TRIANGLE SPRINGS SP-66-2015

Certified Action of the City of Raleigh Planning Commission

Case File / Name: SP-66-15 / Triangle Springs

Staff Report

Preliminary Plan

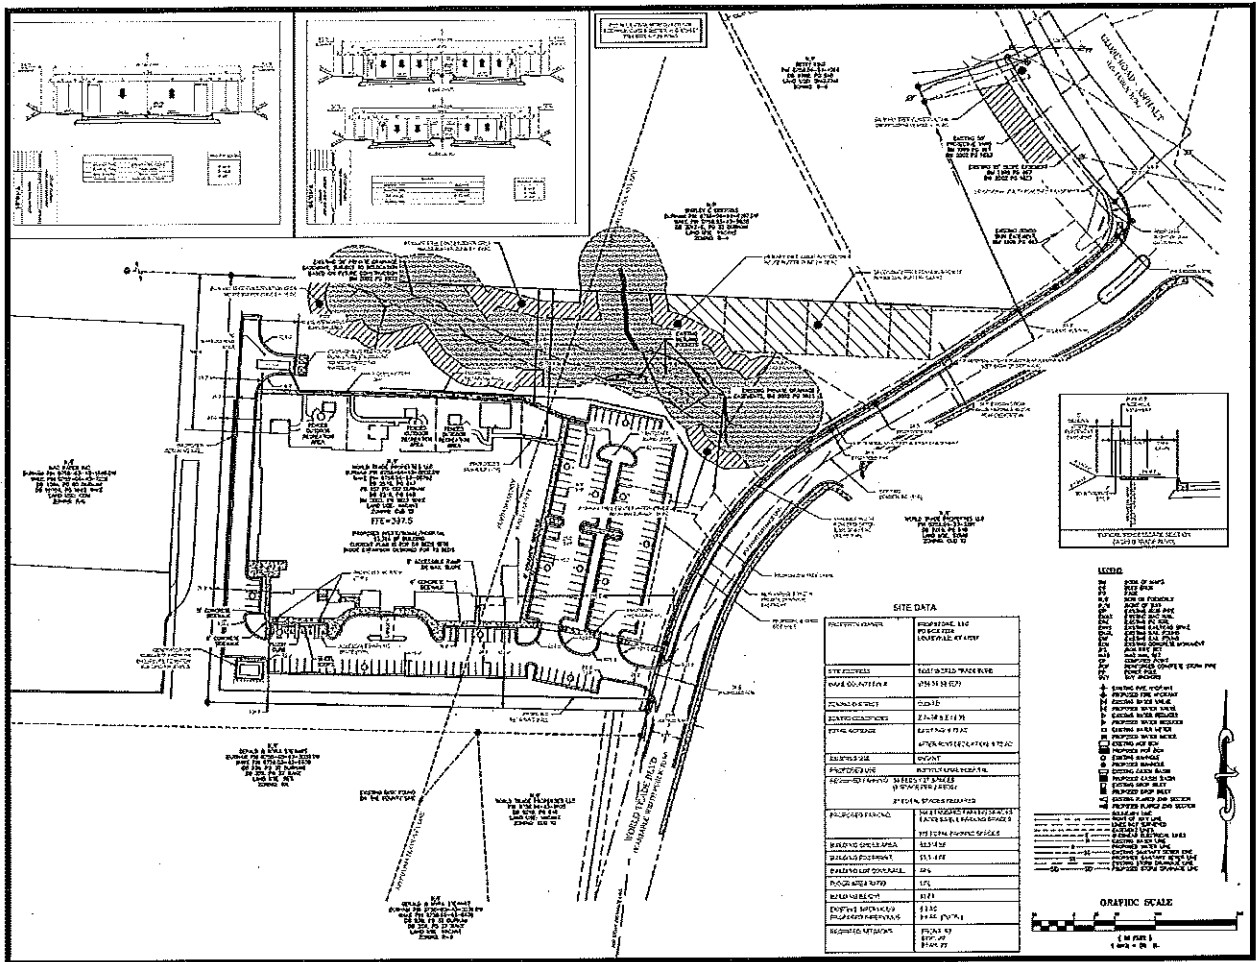
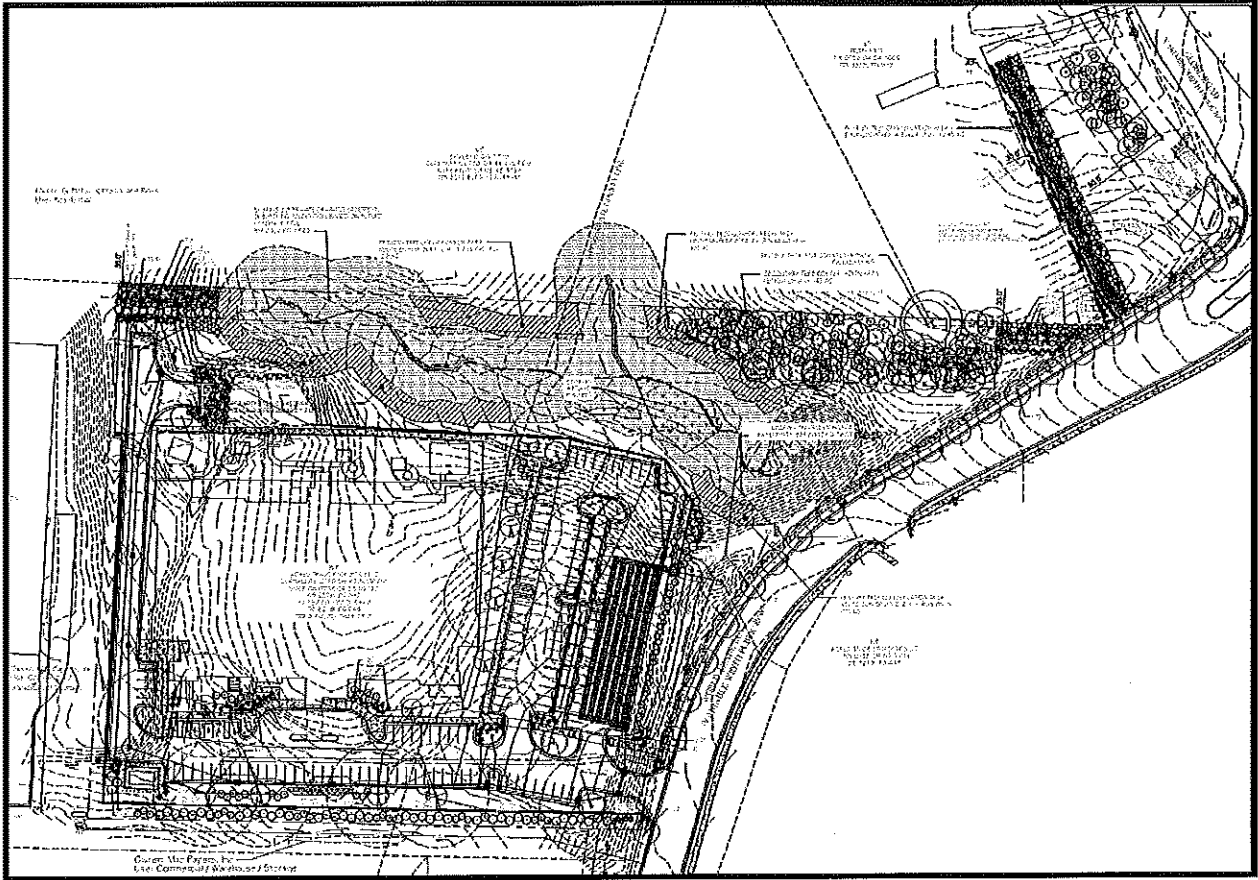
<u>Comment</u>	<u>Response</u>
•The Commission recommends that plantings be added to screen proposed retaining walls, especially for walls facing World Trade Boulevard	<i>Plants have been added to screen walls facing World Trade Blvd</i>
•The Commission recommends considering design alternatives to address the potential heat gains resulting from the large amount of unprotected glazing in the clerestory windows in the south facing lobby of the building	<i>Final architectural design to be determined at time of building permitting.</i>
•The Commission recommends providing architectural detailing to signify an entrance for the outpatient entrance at the southeast corner of the building	<i>Details are shown on building elevations</i>
•The Commission recommends designing and providing a pedestrian entryway and walkway to the outpatient entrance at the southwest corner of the building from the parking lots to the east and south	<i>A pedestrian walkway has been added to the Southeast corner of the building allowing access to the outpatient entrance.</i>

•The Commission recommends switching the trash and recycling dumpster location from the right turn portion of the "T" intersection to the straight portion at the northwest corner of the building in order to locate it further away from the outdoor rehabilitation areas to the north of the building	<i>Additional screening has been added.</i>

•The Commission recommends providing additional plantings around the trash and recycling dumpster enclosure in order to provide additional screening from the outdoor rehabilitation areas to the north of the building

Plants have been added to screen dumpster enclosure
